A meeting of the **WAVERLEY LOCAL PLANNING PANEL** will be held on level 3, Waverley Council Chambers, Cnr Bondi Road and Paul Street, Bondi Junction at:

12.00 PM WEDNESDAY, 24 OCTOBER 2018

WLPP-1810.1 **PAGE 4** **6 Pacific Avenue, Tamarama – Review of previous decision for demolition of existing dwelling and construction of 2 x semi-detached dwellings fronting Pacific Avenue and 1 x detached dwelling fronting Silva Street (DA-471/2017/A)**

Report to the Waverley Local Planning Panel

PROPOSED SOUTH-EAST ELEVATION

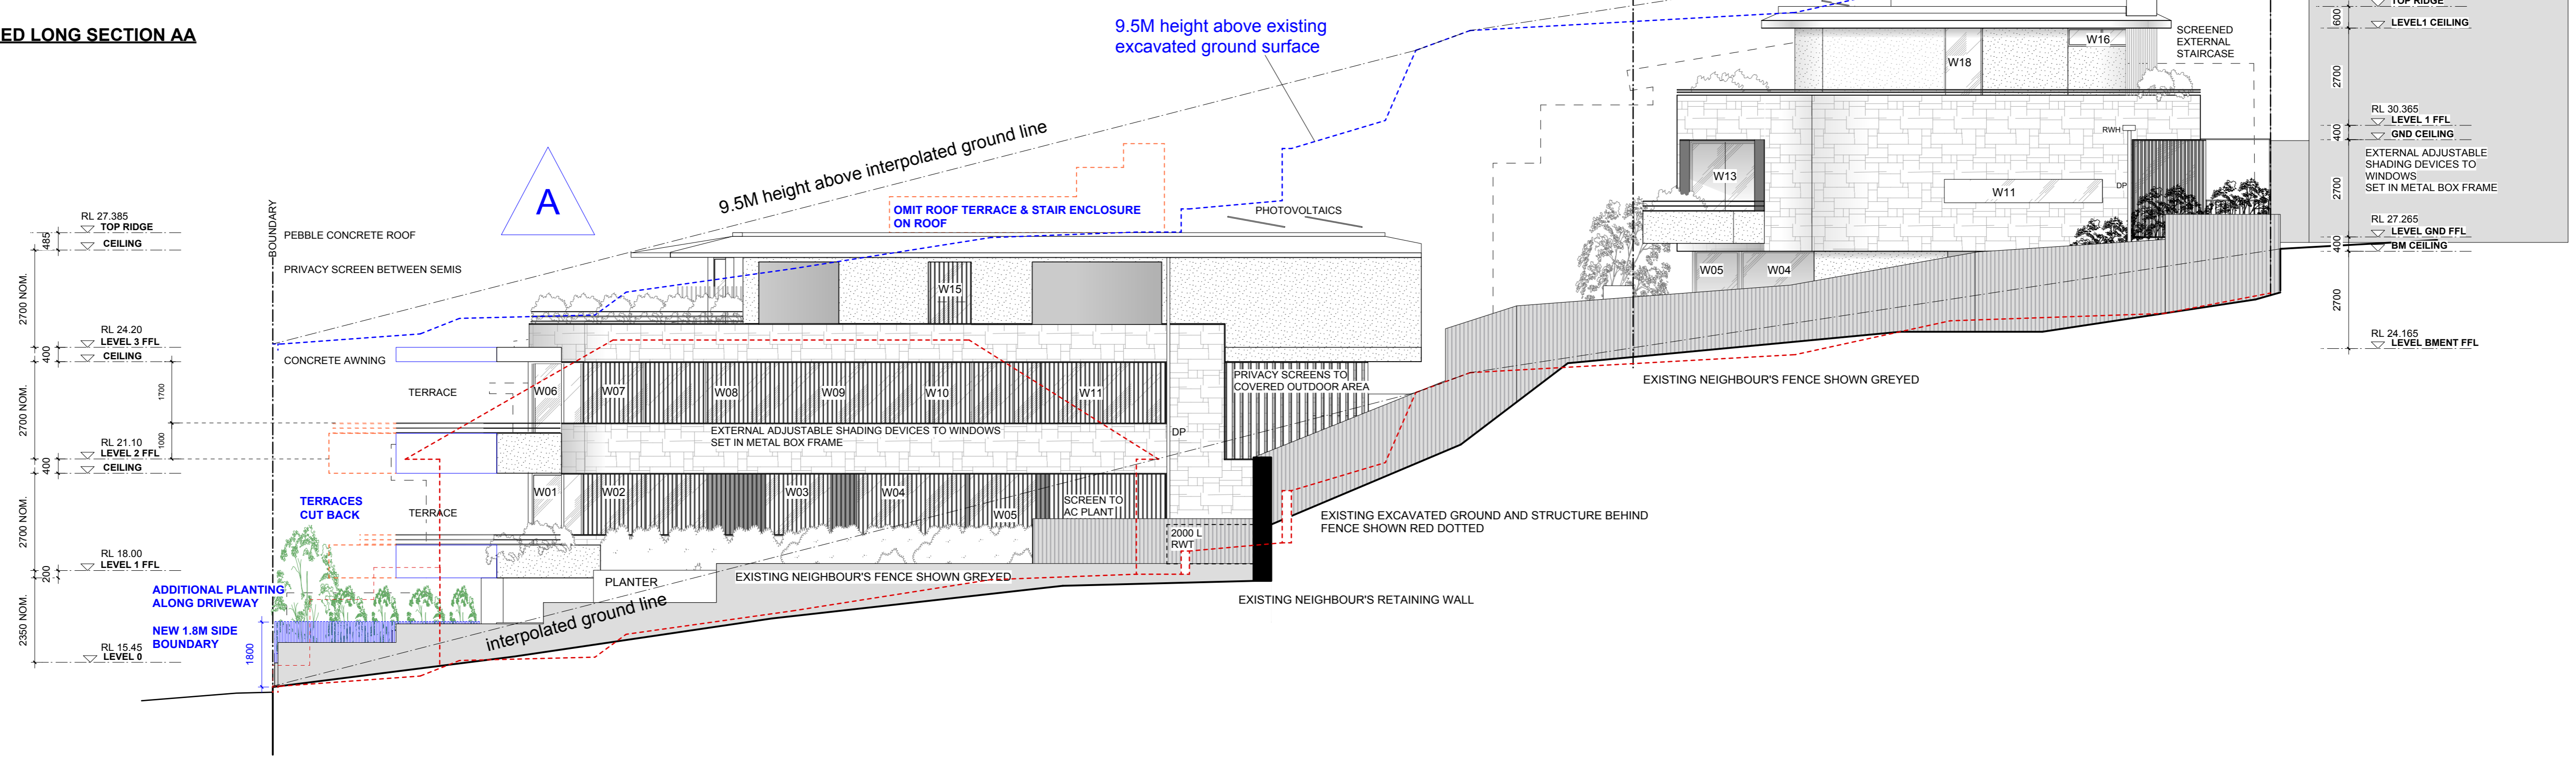
As discussed above under 'Relevant History' DA-501/2015 granted consent for demolition of the existing dwelling and Torrens Title subdivision of the site into 3 lots. Indicative plans were submitted as part of the application for subdivision to provide guidance as to the acceptable built form of future development on the site. These indicative plans were prepared by Molnar Freeman Architects (the same architect as the subject development application). Condition 1 requires that building envelopes for future development have regard to the indicative plans provided under DA-501/2015. The indicative plans and proposed plans are provided below:

The subdivision application was approved based on the indicative plans accommodating a semi-detached dwelling on Lots 1 and 2 and a detached dwelling on Lot 3. The Planner’s Assessment report for DA-501/2015 notes “This indicative plan shows building forms with setbacks and open space capable of complying with the DCP controls”, the report also states that the indicative built form shows compliance with the maximum 9.5m building height and 7m wall height across all lots. At the time of approving DA-501/2015, Council was satisfied that the subdivision was in accordance with the objectives of the Planning Principle (relating to subdivision and design of a future building) and that future built forms can be designed to not have significant adverse impacts to the amenity of neighbouring properties. The applicant has presented a proposal that does not provide any consideration to the assessment or indicative plans of the subdivision application. As such, the application is recommended for refusal.
